PAC BELL PROPOSED ADDITIONS

As per our conversation yesterday, I am writing you a letter re the proposed construction/additions at Pac Bell/Golden Bough Theaters.

I submit this letter commenting on the above referenced Mitigated Negative Declaration (MND) on behalf of my clients and neighbors of the project. The MND is legally inadequate, fails to accurately describe and analyze the whole of the project, is premised on wrong information, fails to analyze the project under applicable General Plan and zoning standards, and fails to adequately mitigate significant impacts of the project. Accordingly, the project cannot be approved on the basis of this MND. Absent a major redesign of the project to conform with the City's General Plan and zoning standards and/or imposition of substantial new mitigation measures that would ensure such conformity and eliminate the possibility of subsequent development phases, an environmental impact report is legally required for the project.

A review of the code elements applicable to the proposed upgrades to the Circle Theater at the Golden Bough (see separate Report Part I) shows that the project as submitted does not comply with a number of code r

Figure 3: Option 'C' – Project as Submitted
(Proposed expansion area shown hatched)

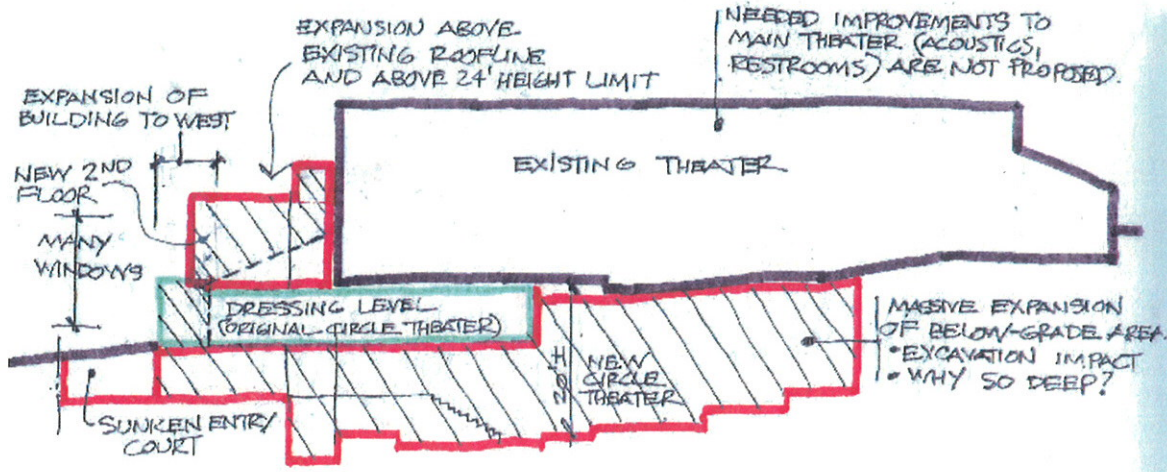
Project as Submitted (Option 'C'): The proposed design includes increases in floor area, volume, expansion of the building to the west and south of the existing footprint, and an increase in the seating capacity in the Circle Theater from 99 to 120. Much of the expansion is below grade, lessening the impact of increased mass, but requiring major excavation beneath the existing building. The new Circle Theater would be lowered two stories beneath the existing theater level; the existing level would become a new dressing room level serving both the Circle Theater and the Main Golden Bough.

Figure 6: Proposed below-grade Circle Theater as submitted (Option 'C').

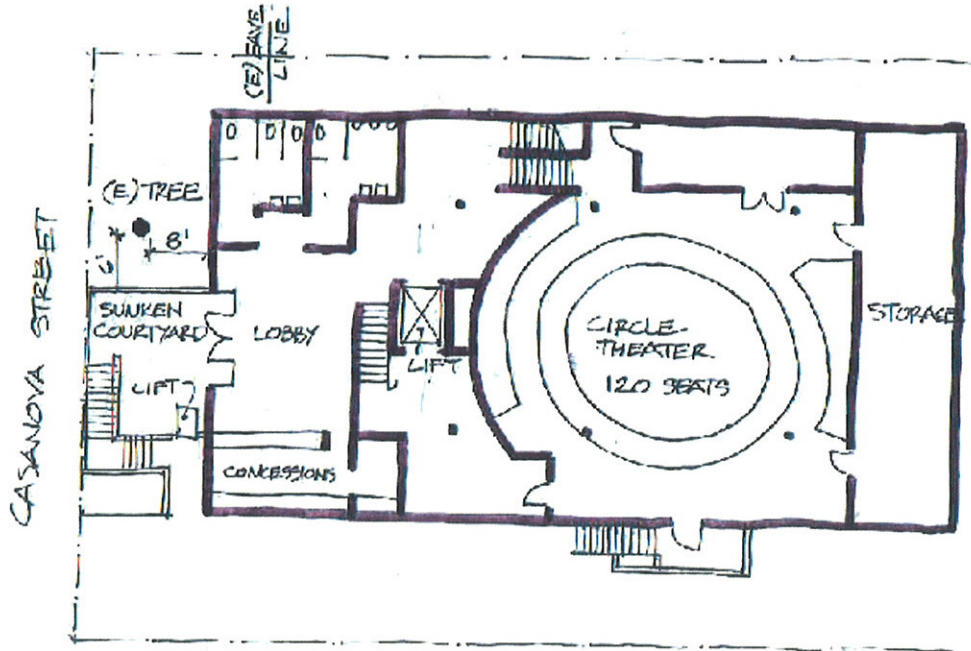
The proposed new Circle Theater as submitted is accessed via a sunken courtyard, entering into a larger lobby one floor below grade. The theater itself is almost one additional floor deeper, for fly space above the theater. The result is a complex series of stairs and elevators needed to move patrons and persons with disabilities down to the theater level, over twenty feet below the structure above.

The west wall of the new theater level has been expanded to the west approximately seventeen feet from the current Circle Theater west wall. This projection is beyond the existing eave line, and is very close to a significant (48" diameter) pine tree. The sunken courtyard accessing the

new theater level is within six feet of the same tree; these two encroachments on the root structure will significantly endanger the tree beyond preservation methods laid out in the Initial Study. The theater itself has been enlarged from a capacity of 99 seats to 120 seats, which will substantially increase parking, pedestrian and traffic impacts on the surrounding neighborhood.

Figure 9: Dressing Level (former Circle theater) as submitted (Option 'C')

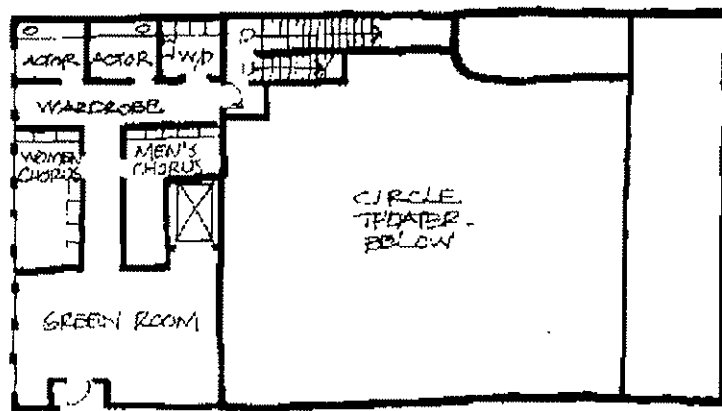
Sandwiched between the existing Golden Bough theater and the new subterranean Circle Theater is a dressing level, serving both theaters. This critical level is not well defined in the proposal as submitted. No restroom facilities are provided for all the actors dressing and rehearsing on this level. Ten windows shown on the street-facing west façade appear to be arbitrary, placed at random in dressing and wardrobe rooms, with two windows intersected by interior partitions. A note on the submittal drawing states: "*Dressing and Wardrobe Build out Pending Future Planning and Funding*". Because of the apparent critical role provided by the dressing level for productions in both the Circle Theater and Golden Bough Theater, this element should be addressed in detail prior to project review to address potential significant impacts..

Figure 12: Backstage Support Area – as submitted (Option 'C').

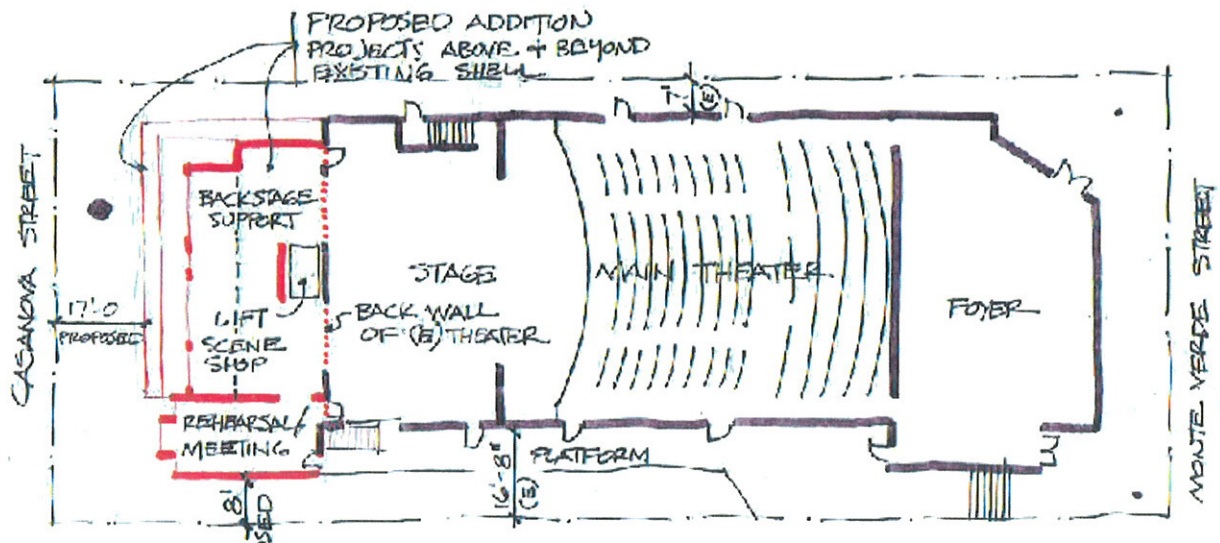
Expansion of the Main Stage Level is the most impacting element of the proposed design as submitted. The needed scene shop is very large, with many huge windows for natural light to the space, but mainly to capture the ocean view. The adjacent practice/meeting room is also quite large. The elevator, incorporated within the Golden Bough existing shell in previous designs, has now been relocated into the addition, forcing the entire addition seven feet to the west and pushing the roof up several feet for elevator clearance. The size of the proposed spaces, attached to the mass of the existing building, creates an imposing structure looming over Casanova Street in addition to blocking views, privacy and sunlight at the house to the north. The meeting room is cantilevered over the loading area, with the south wall only eight feet from the south property line. Cumulative setback requirements call for a minimum thirteen-foot south side setback to combine with the existing seven-foot north setback.

Figure 16: Casanova Street Elevation – design as submitted (Option 'C')

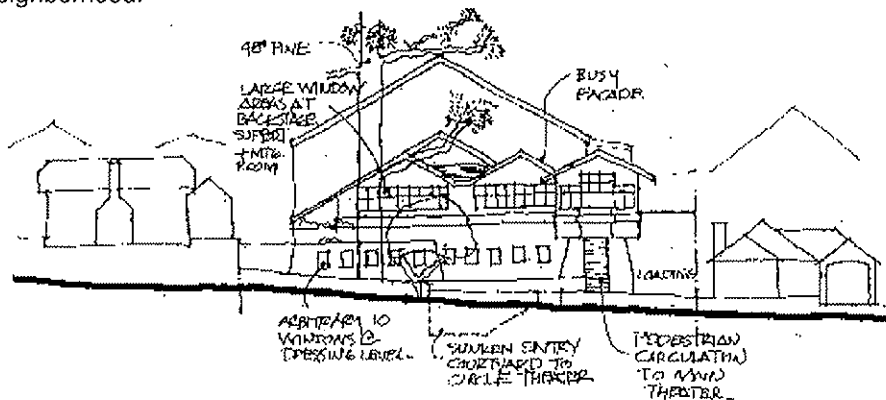
The elevator shaft location in the addition (rather than within the existing building shell) creates an additional higher roof element at the top of the elevator shaft. Rooftop planters at the first and second floor levels might provide a pleasant softening of the façade – but only if properly planted, watered and maintained. The sunken entry court serving the Circle Theater is well within the root area of the existing significant tree. The exterior stair between Casanova Street and the upper level platform introduces potential changes in patron and staff parking patterns in the neighborhood.

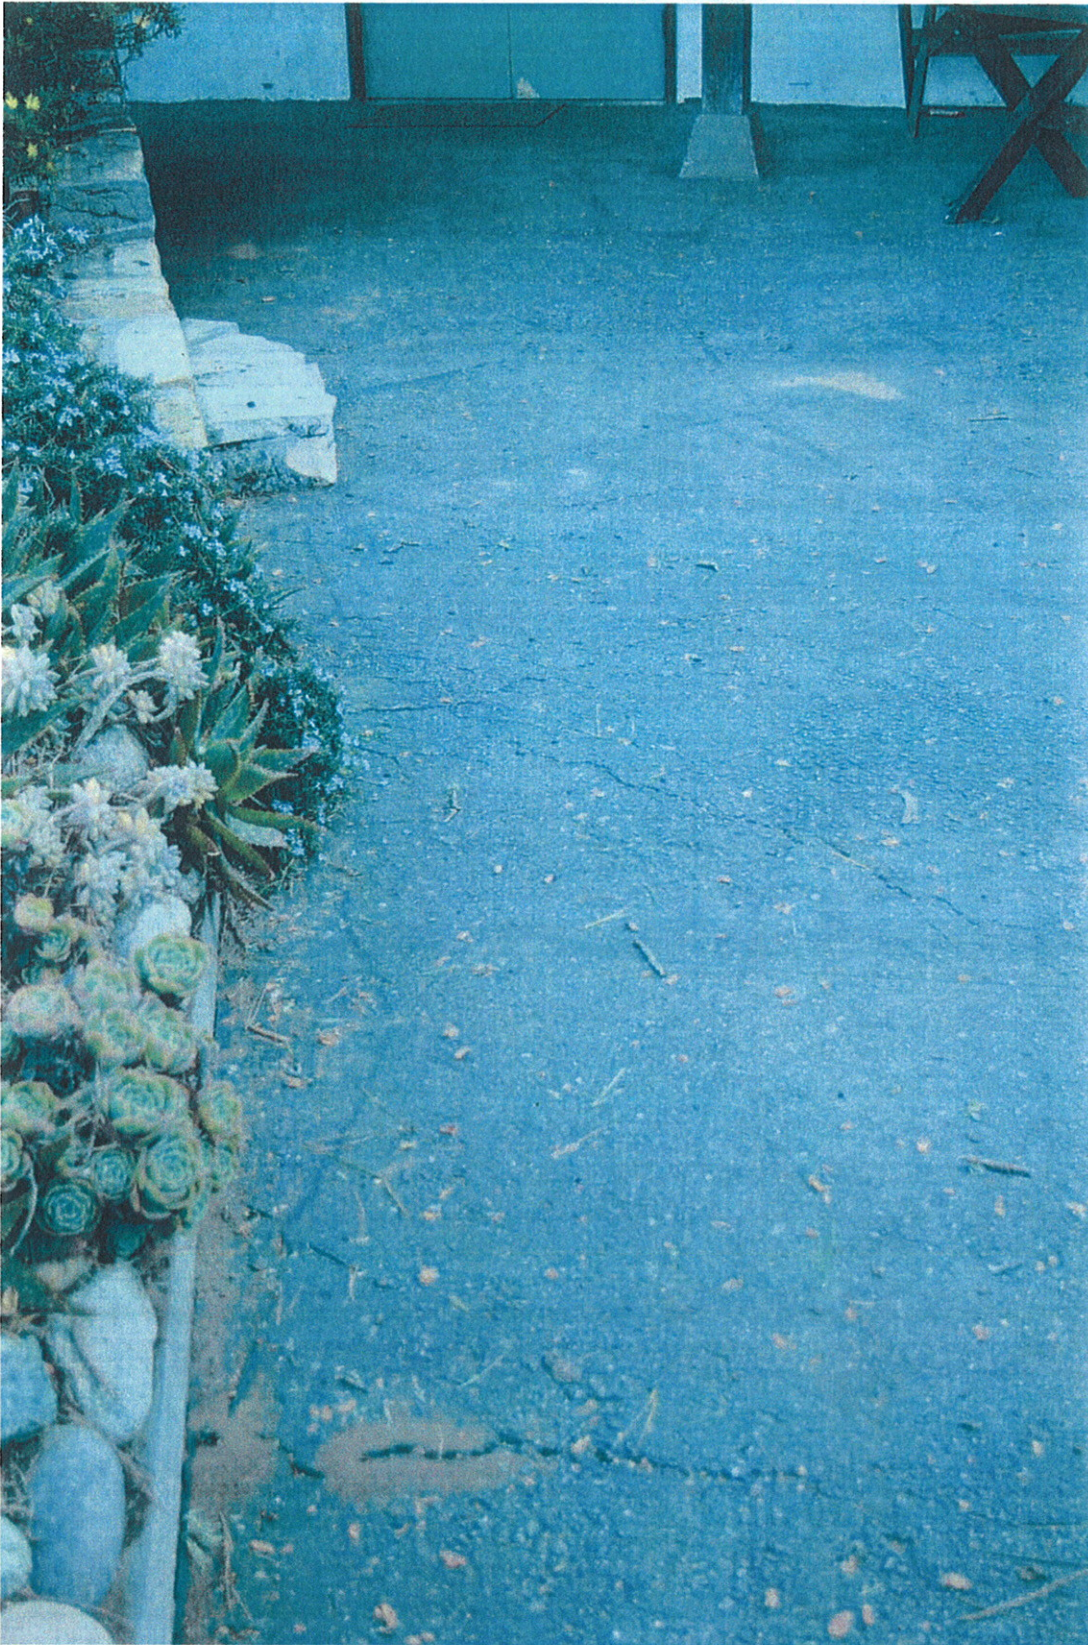
Retaining wall will be required for deep excavation for footings and excavation removing roots in indicated areas

Cracks in asphalt correspond with areas where soil and roots must be removed.
